Texas A&M University - Corpus Christi Chaparral Building Renovations

TAMU-CC Project #157191FY21 TAMU-CC Proposal #CSP3-003

Issue Date: 09/07/2023

MAKE THE FOLLOWING ADDITIONS, MODIFICATIONS OR DELETIONS TO THE DRAWINGS AND SPECIFICATIONS

P1.100

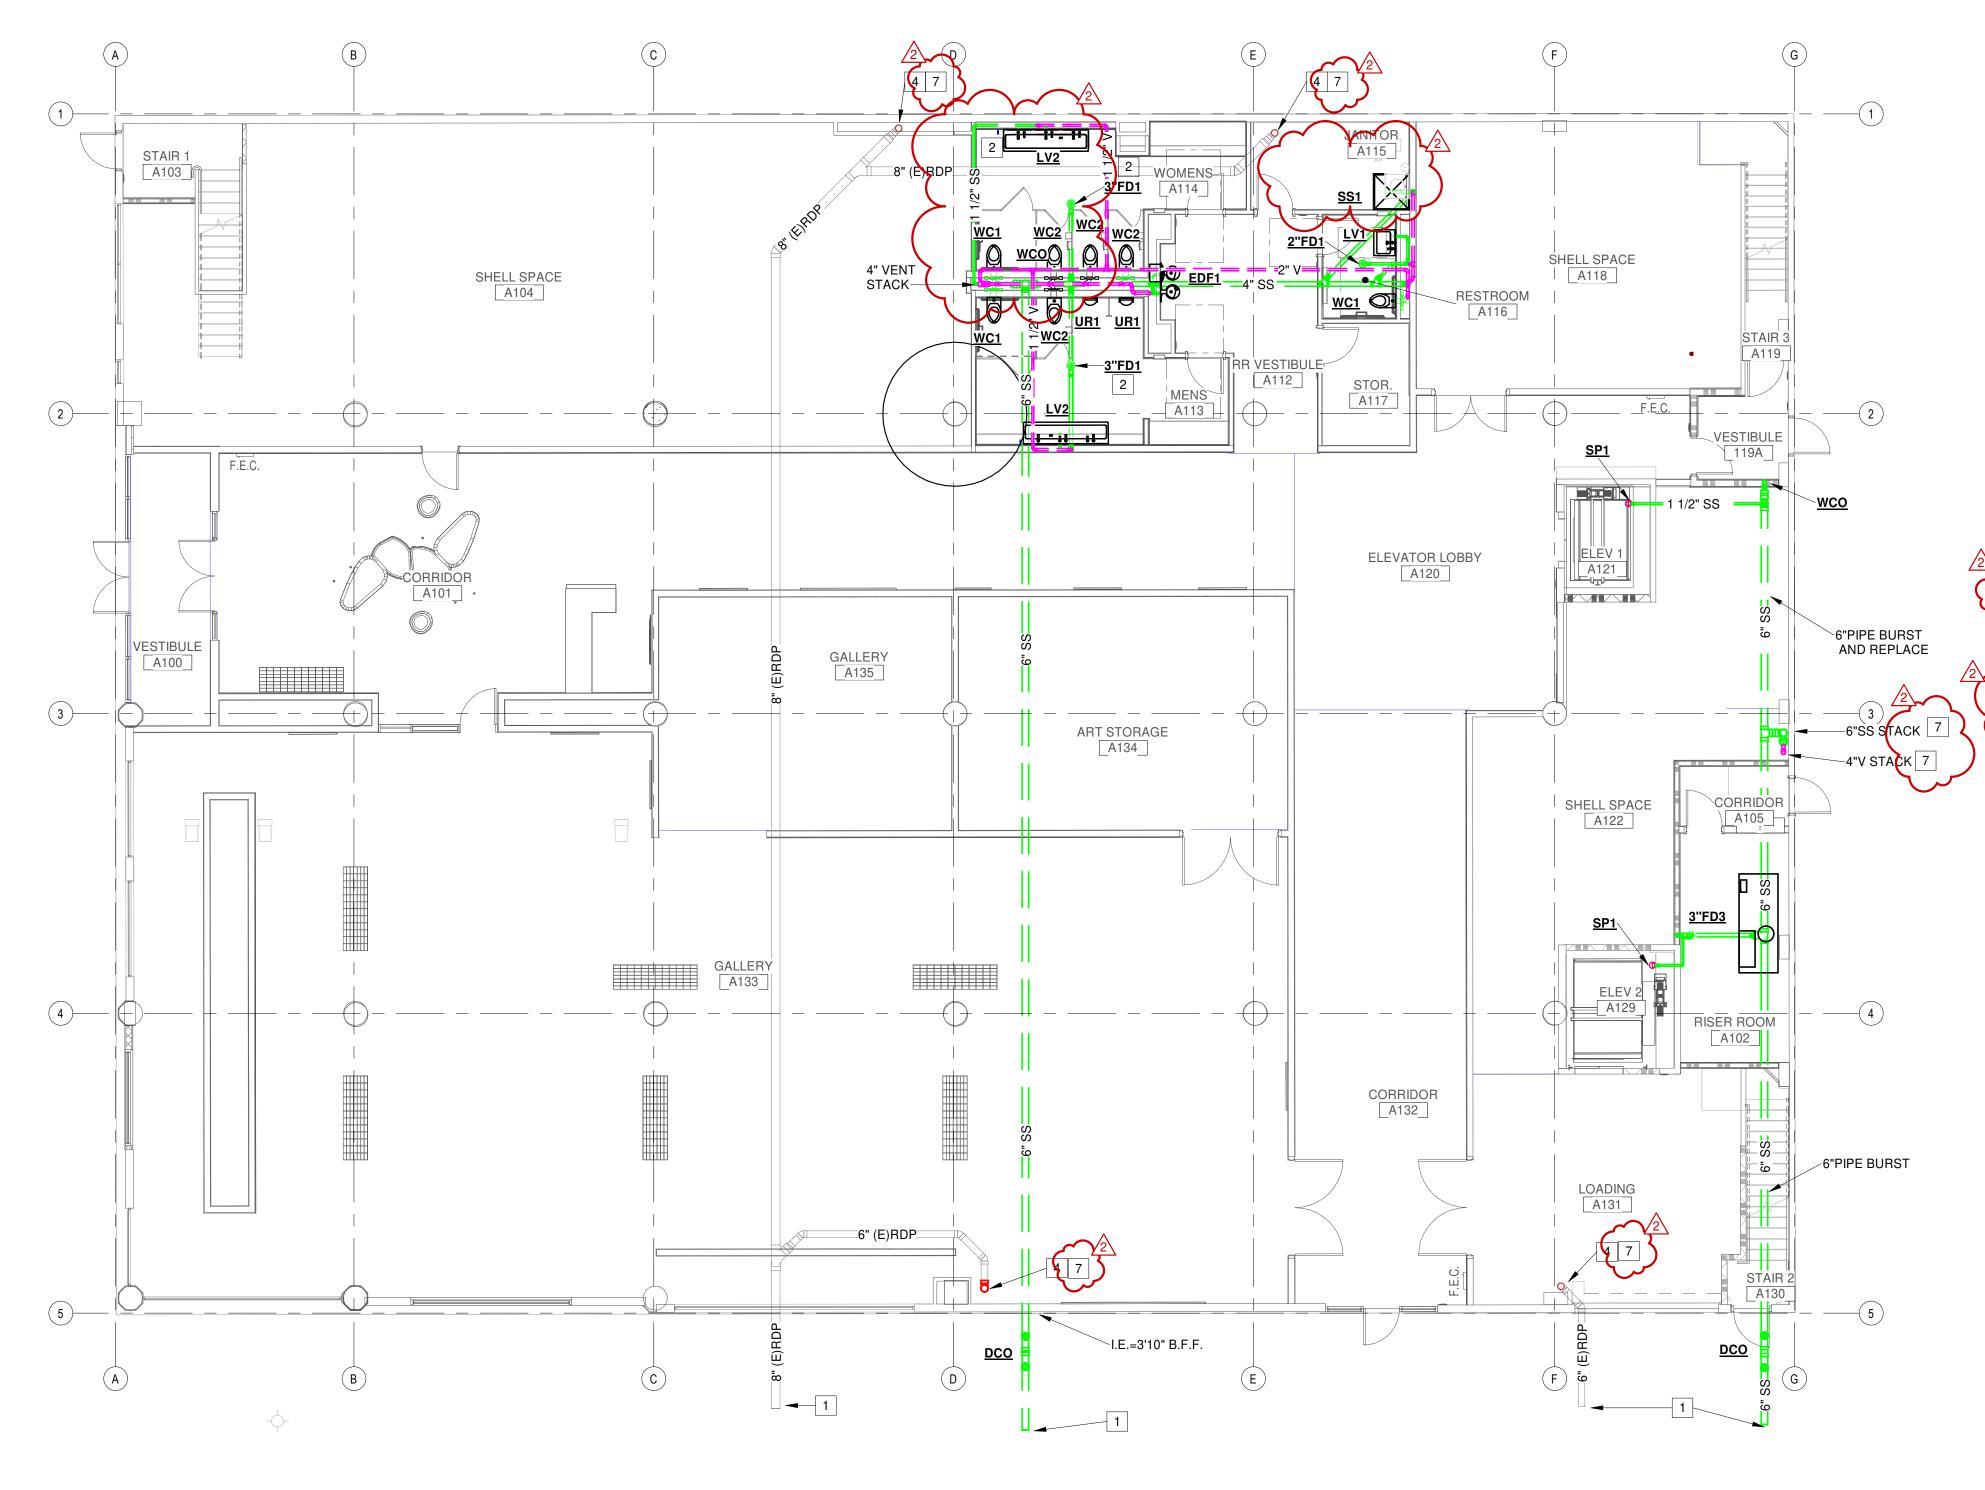
RESPONSE: Ductwork shall be a double wall with a thermal R-value of 6.
- ITEM No.40 Plumbing Sheet P1.100 shows below grade and below slab 6" SS (Sanitary Sewer) beneath existing slab. Who is responsible for saw cutting and patching of the existing slab for this system?

RESPONSE: Reference structural drawings and coordinate with GC.
